Subject: Enrollment of THP 1-10-070 HUM in the Elk River WWDR, "Tier II"

THP Unit Review for Tier 2 Enrollment

THP: LNFE Lake Creek THP 00-000 Unit # 1 January 27, 2011

Erosion Control Plan (ECP) for the "LNFE Lake Creek" THP

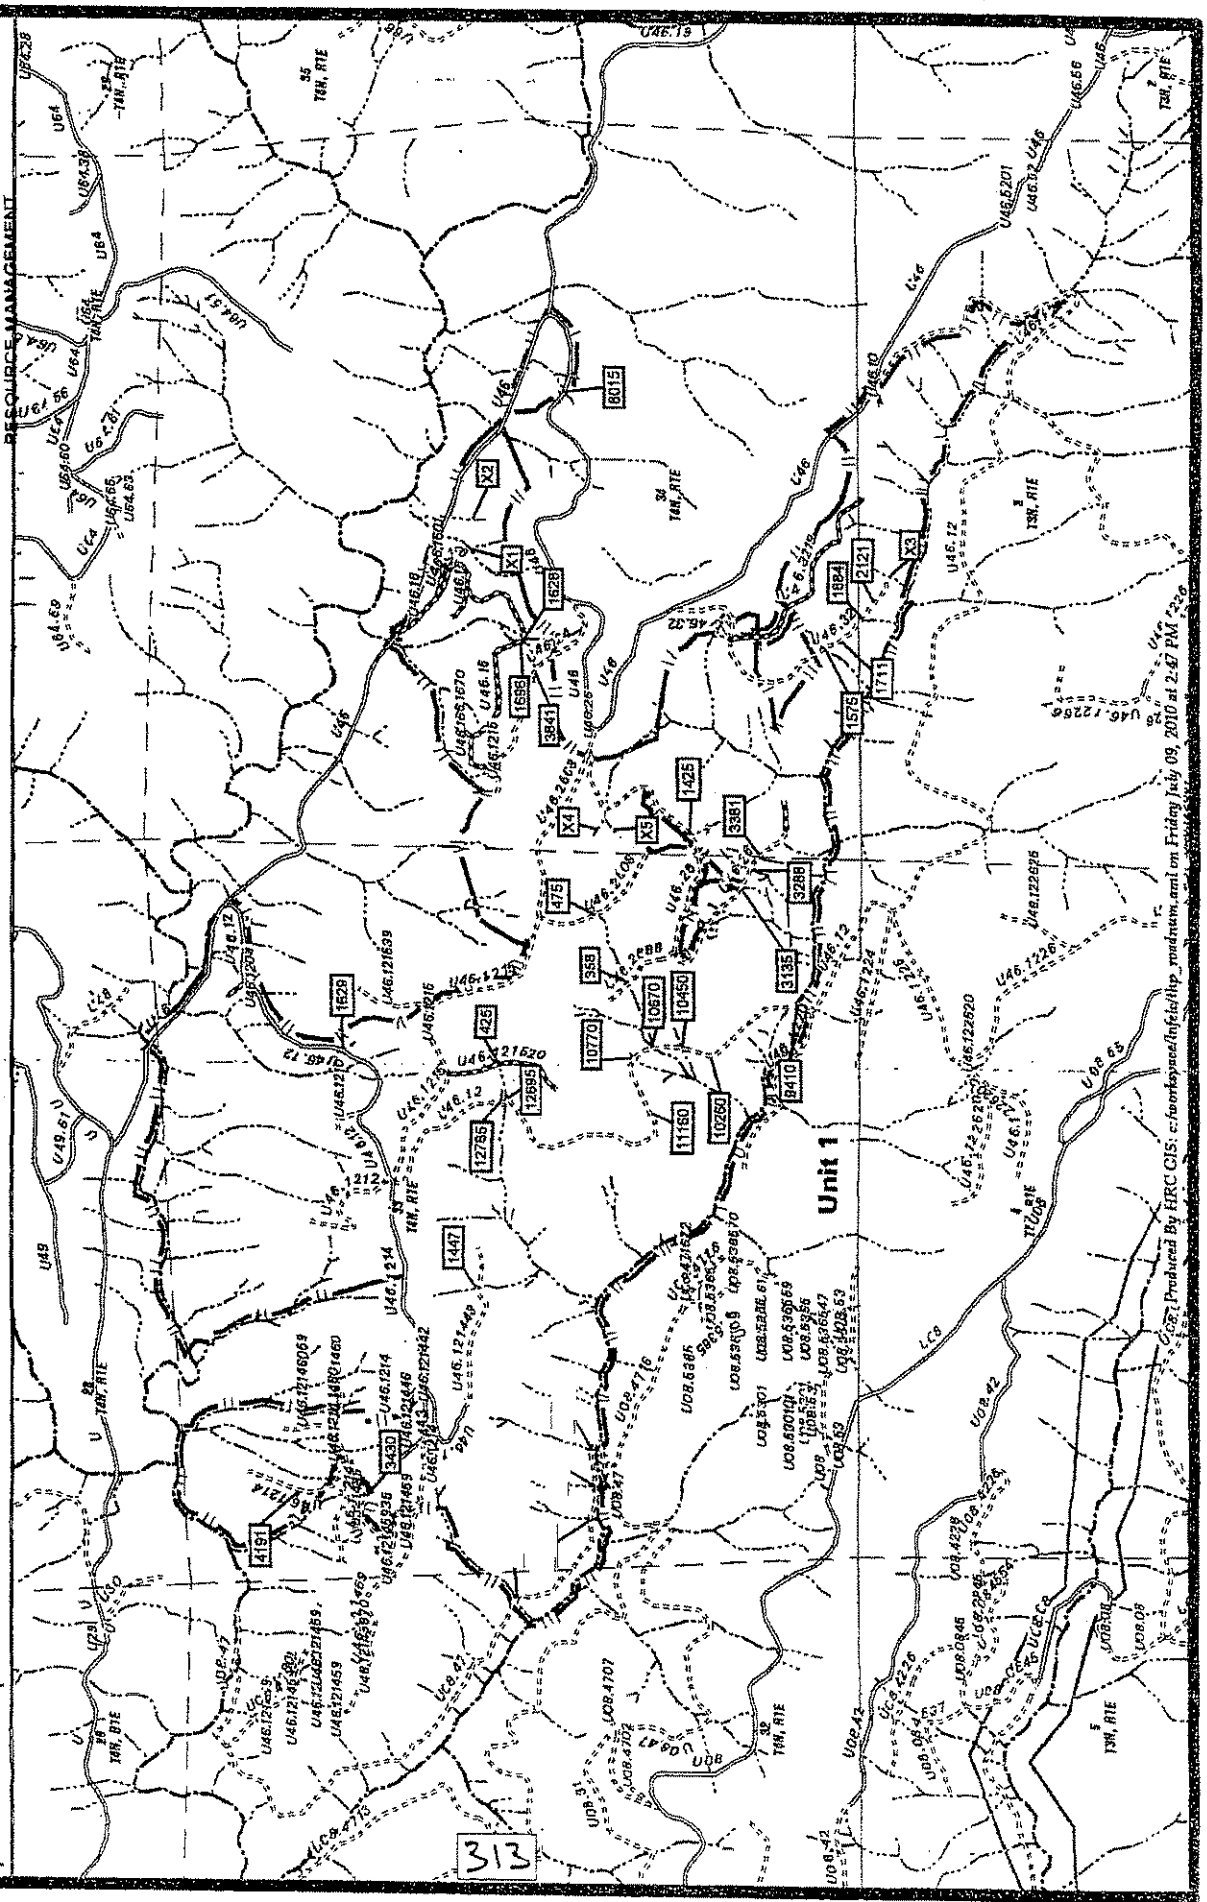
I have reviewed all of the ECP sites for 1-10-070 HUM, LNFE Lake. These sites are located within the Tier 2 portions of the plan. While you have not yet submitted your Tier 2 application for this plan, I want to give you advance notice of my review. My recommendations are as follows.

5519. The latter site is listed as 68 cubic yards, but in the field it looked to be a much larger situation. I have discussed these sites with Holly Lundborg who was a major person in writing the orders and is an expert in ECPs. She feels that you need to include these sites in your ECP and develop a plan to fix them in the near future. Stations 4872 and 5519 shall be included in your ECP and a plan developed to fix them prior to enrollment.

- 2) I am concerned about the U08.47 crossing of Lake Creek. The WMDRs state under the erosion control plan section (2.a), Overview "Controllable Sediment Discharge Sources may include, but are not limited to...unstable deposits... or any other location near watercourses, unstable watercourse banks... instream and floodplain sediment deposits... or any other location discharging sediment or earthen materials." A picture showing a shotgunned culvert that extends from the floodplain out to the watercourse indicates there is fill at this location. This indicates to me that this crossing should be included in your ECP and treated.

- 3) Road U46, Station 3448. This site is already in your Road Work Order and is scheduled to be repaired. This site involves a leaking culvert. When culverts leak, they erode the soil material that surrounds the culvert. That is the reason that we replace leaky culverts. This culvert is located on a Class III tributary that leads just a couple hundred feet into the North Fork Elk River. As a result, this road point must be added to the ECP and a plan included to fix the site prior to enrollment.

- 5) Road U46.12, Station 12785. The ECP in the Treatment section states that the site shall be corrected by October 15 of the year site is opened. However the Implementation Schedule states that it should be fixed "Prior to THP Final Completion. The road segment lists 8000 cubic yards and the road site lists 400 cubic yards of potential sediment delivery. Road site 12785 is located on a Class III tributary to Lake Creek. Both the road segment and the specific site will have the Implementation changed to Prior to end of 2nd year or the 1st year of operations in this portion of the plan" prior to enrollment.

- 6) Road U46.32, Station 2314. This site is also known as X3 and is a CAO site. The site lies just a hundred feet from the end of the road segment that is planned to be opened up. However, it is obvious that the former road in this area extended to this site. There is no major obstacle that would prevent easily reaching this site with equipment. If the road segment leading to this is abandoned as planned, it will strand this CAO site thereby preventing cleaning it up in the future. This site is along a Class III watercourse. The watercourse may have been classified incorrectly as it appears to be a Class II. This watercourse leads within a short distance directly into Lake Creek. This site shall be included in the ECP prior to the plan being enrolled.

2. Same answer as above - we will not be using this road for timber operations and it will not be orphaned.
3. It is a leak into the culvert not out of. As I discussed with Mark I was under the impression this did not need to be in the ECP. For ease of process I will put this in

4. As discussed with Mark I was under the impression this site did not need to be in the ECP. For ease of process I will put this in
5. the intention is to fix it the first year we use it. made the change.
